## Trigger Modification - 250/275

Mariner and Mercury

250/275 Models

Replacement Cylinder Block and Powerhead Assemblies

**FIGURE 2. NEW BEARING P/N 31-816773A1**

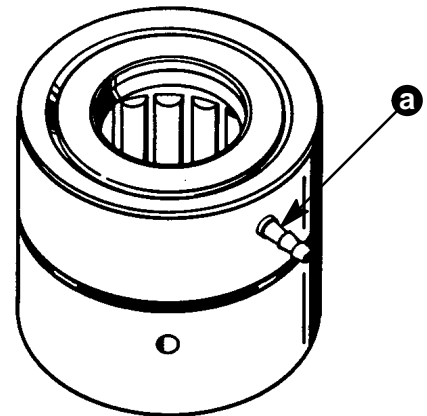
Replacement cylinder blocks and powerhead assemblies listed for older models have the new upper crankshaft bearing P/N 31-816773A1. The new upper crankshaft bearing has a bleed fitting installed in the outer race and requires modification of the previous trigger P/N 89004A5 or a new trigger P/N 89004A7 to provide clearance for the bleed fitting.

a - Bleed Fitting Above Both Rows of Rollers

**FIGURE 3. PREVIOUS TRIGGER P/N 89004A5**

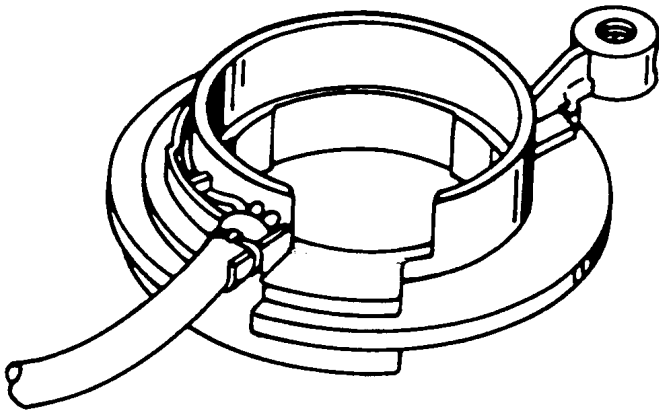
**TRIGGER MODIFICATION:**

Carefully remove material 1-3/8 inches (35mm) wide and even with the flat surface to allow clearance for bleed fitting. Round corners with sand paper.

- a - 1-3/8 inch (35mm)
- b - Remove Material
- c - Flat Surface

**FIGURE 4. NEW TRIGGER P/N 89004A7**  
Previous trigger supersedes to new trigger.  
P/N 89004A5 Superseded to: P/N 98004A7

**FIGURE 5. TOP VIEW OF CYLINDER BLOCK**

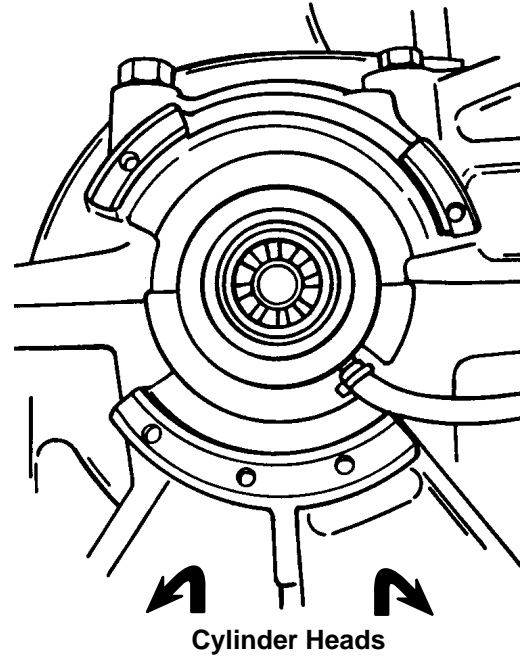
When servicing a 250 or 275 with the new upper crankshaft bearing with the bleed fitting, the bleed line sta-strap locking tab must be turned towards the rear of the engine to provide clearance for the trigger arm (Figure 5).
